CITY OF FALLS CHURCH

SUBJECT: Worksession
Conditional Rezoning Application #20081039
120 N. Lee Street and 609 Park Avenue (The Palatium)

Re: The Palatium Office @ 609 Park Avenue
Parking Study Review

VHB Review Comments

P1 GARAGE SCALE 1"=20'

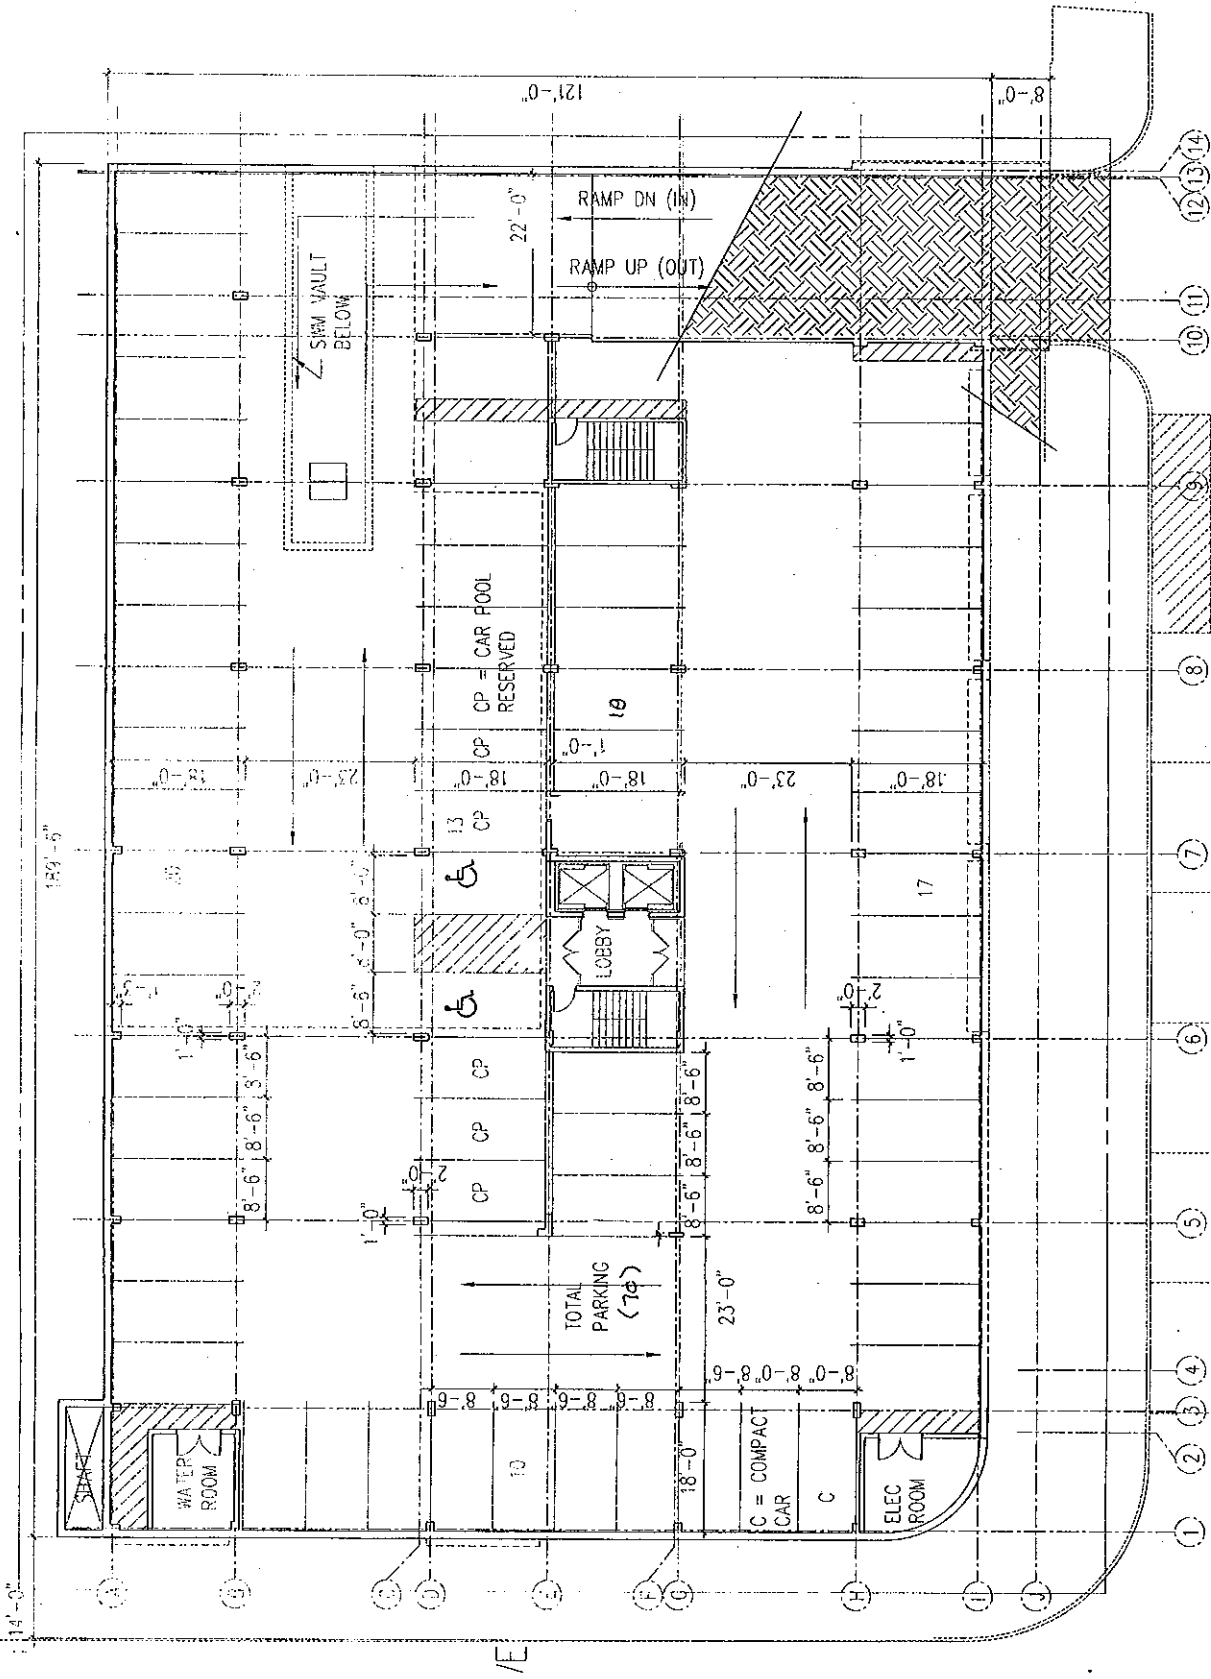
Parking remains the most critical issue for staff. Staff finds the ratio of on-site parking spaces to the square footage proposed in the project to be insufficient, and the greatest challenge to providing a redevelopment that is appropriate for the location, and compatible with adjacent property and land uses. Staff estimates that the parking reduction is the greatest proposed by an applicant to date.

The applicant is proposing 113 parking spaces. Within the 113 spaces, it is proposed that six spaces will be reserved as carpool spaces. Mixed Use Redevelopment (MUR) provisions do not allow for reserved parking, so the number of available parking spaces is actually 107. Based on the uses and proposed square footages provided by the applicant, the Code would require 169 parking spaces, and when applying the MUR matrix, 146 parking spaces would be required.

Staff notes that because the reserved carpool spaces cannot be counted towards required parking, the requested reduction to required parking will likely be higher than 19.3%.

- The proposed square footages used for the various components of the mixed-used site in Tables 1 and 2, could not be confirmed from the site plans provided with the parking analysis memo. To provide accurate analysis, the correct proposed development mix must be known.
- In Table 2, the "Proposed Parking" for restaurant is taken to be 10, with the justification that parking ratios of 1 space per 150 sq. ft. has been approved for another project. However, no such approval has been given to the proposed site. In addition, parking uses vary according to the type of restaurant proposed. Therefore, this justification is not supported by any engineering opinion.
